# Technical Service Information

## **THM 4L60 (700-R4) PREMATURE 3-4 CLUTCH FAILURE**

Figure 1

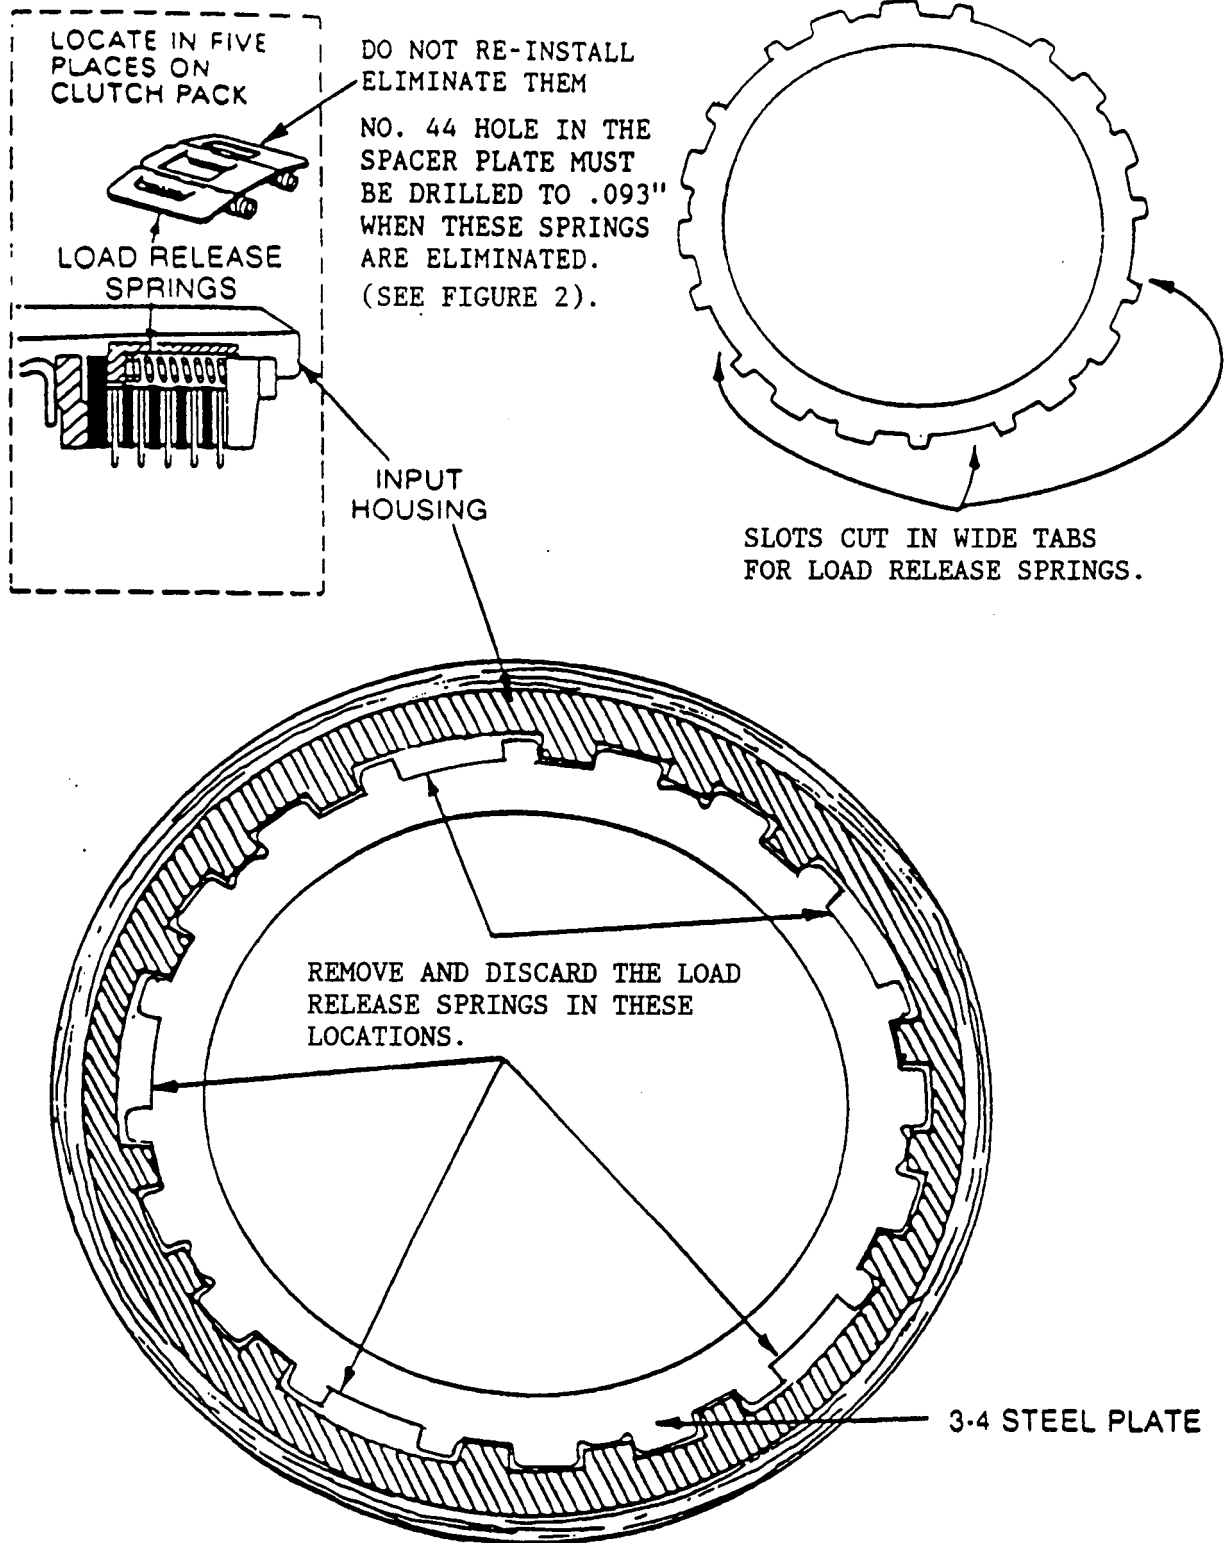
**COMPLAINT:** Premature 3-4 clutch failure on 1988 to 1992 model 700-R4 transmissions, and can occur as early as 200 miles on the unit.

**CAUSE:** The cause may be too much spring pressure for available 3-4 clutch oil pressure to overcome.

**CORRECTION:** Remove and discard the 3-4 Load Release Spring Assemblies, on ALL vehicles so equipped (See Figure 1). Drill hole marked 'ID' in the spacer plate out to .093", as shown in Figure 2. This hole was eliminated on 1988 and later 5.7L models. If your spacer plate does not have this hole, use the gasket as a template and drill it to .093" (See Figure 2). Set the 3-4 clutch clearance to .050"-.060".

**NOTE: WITH THE 3-4 LOAD RELEASE SPRINGS REMOVED, IT ALLOWS YOU TO INSTALL THE STEEL PLATES IMPROPERLY. PROPER INSTALLATION IS WITH THE STEEL PLATES INSTALLED SO THAT THE LOAD RELEASE SPRINGS WOULD FIT, IF WE WERE GOING TO USE THEM.**

**Figure 2**

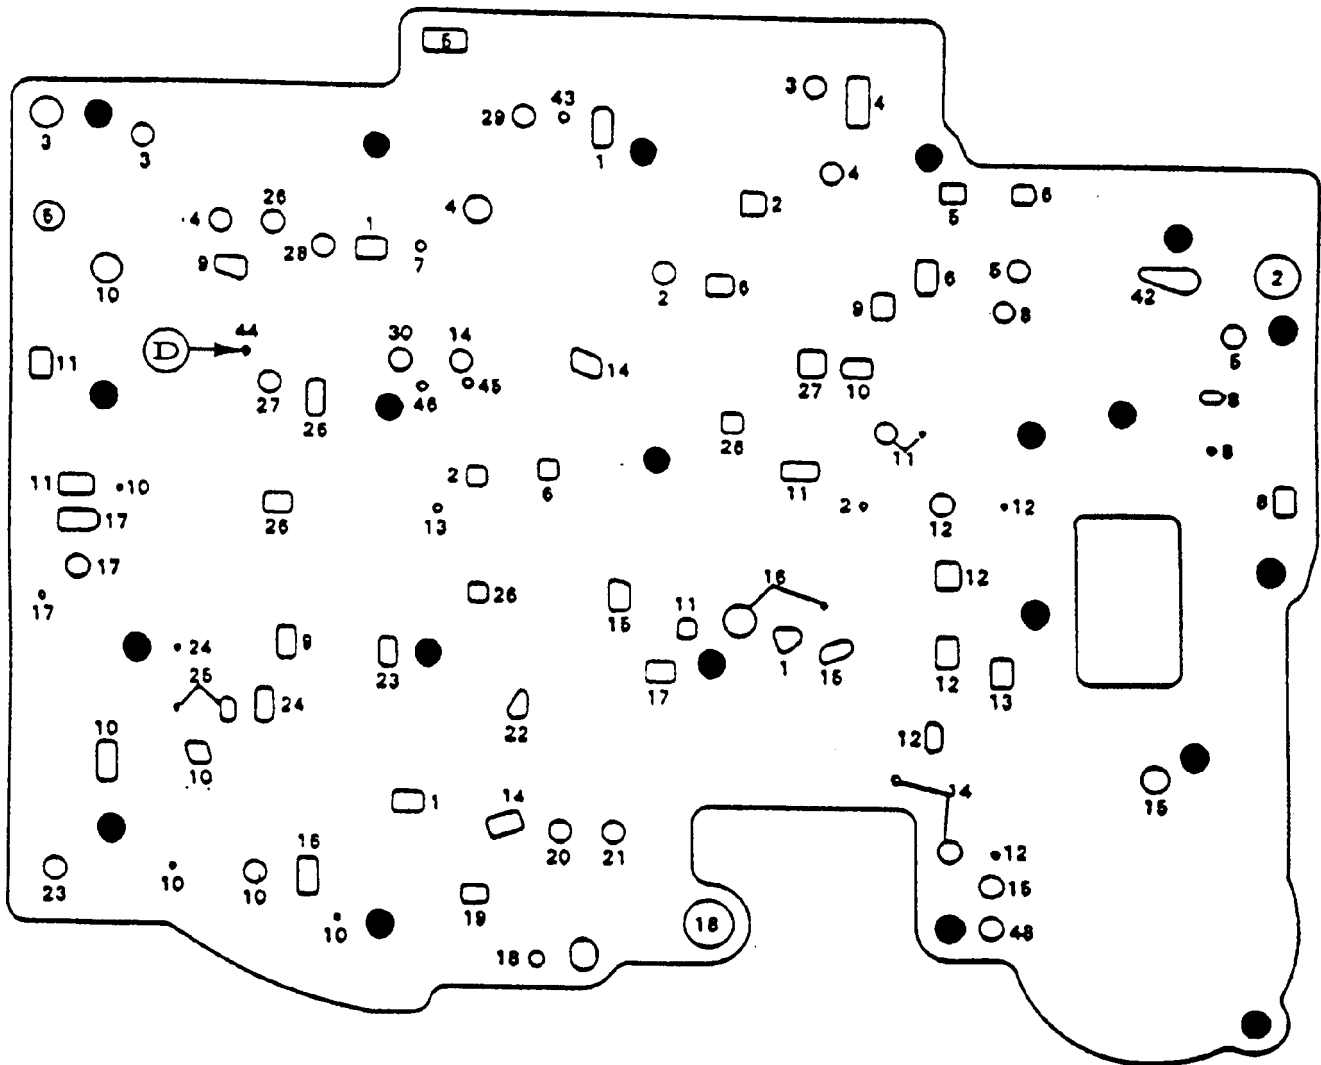
**DRILL HOLE "D" TO .093"  
EVEN IF THERE IS NO HOLE IN THIS LOCATION**
